CMA PRODUCT IMPROVEMENT

Effective Date: SEPTEMBER 1, 2014
Log Number: CMA-PI-455
Subject: CMA OPTIONAL 3-DOOR INNER PANEL
Models Affected: E, EST, E EXT, EST EXT, CMA-180, CMA-180 TALL, CMA-180VL, CMA-180VL TALL

CMA Optional 3-Door Inner Panel

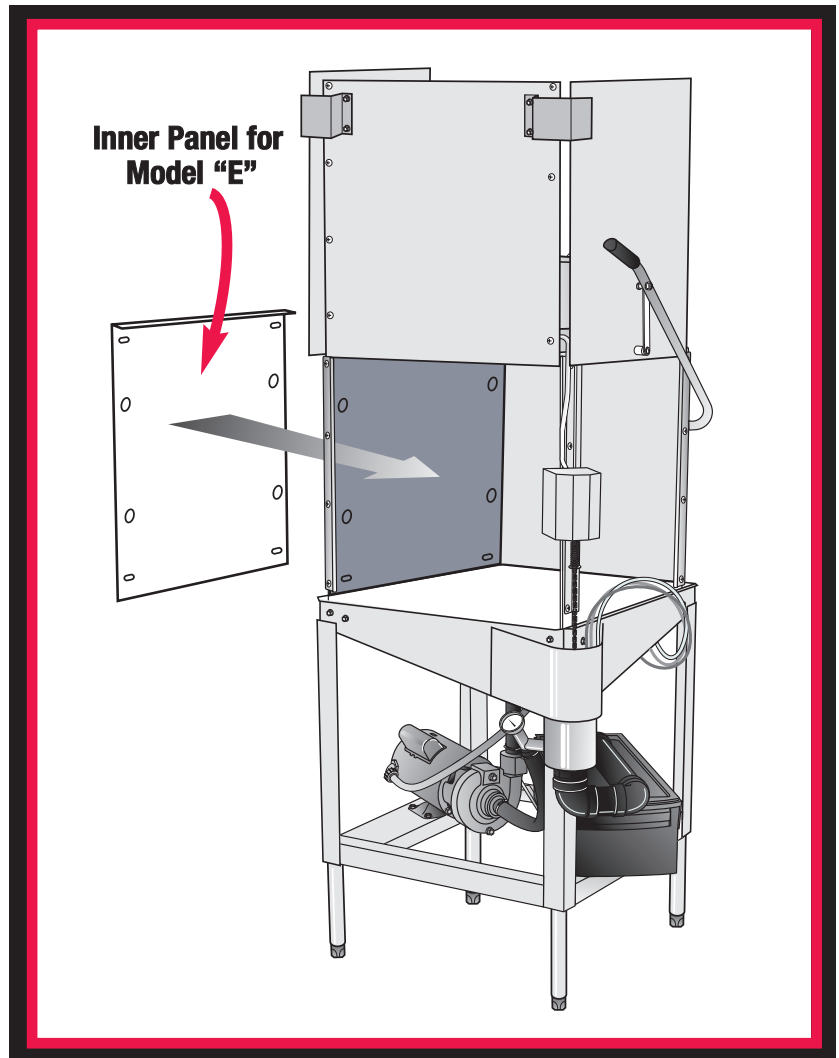
CMA offers an optional Inner Panel for the CMA 3D “Corner” models listed below. The Inner Panel can be added to the door opening closest to the wall, on “Corner” models only. The panel will prevent water from spraying on the kitchen wall, when the 3 doors are lifted at end of cycle.

To install the optional panel on “Corner” models, remove the doorstop and discard. Remove the (4) corner door-guide bolts (only), and place the panel into position. Reinstall the “Corner” bolt hardware, and secure panel into place.
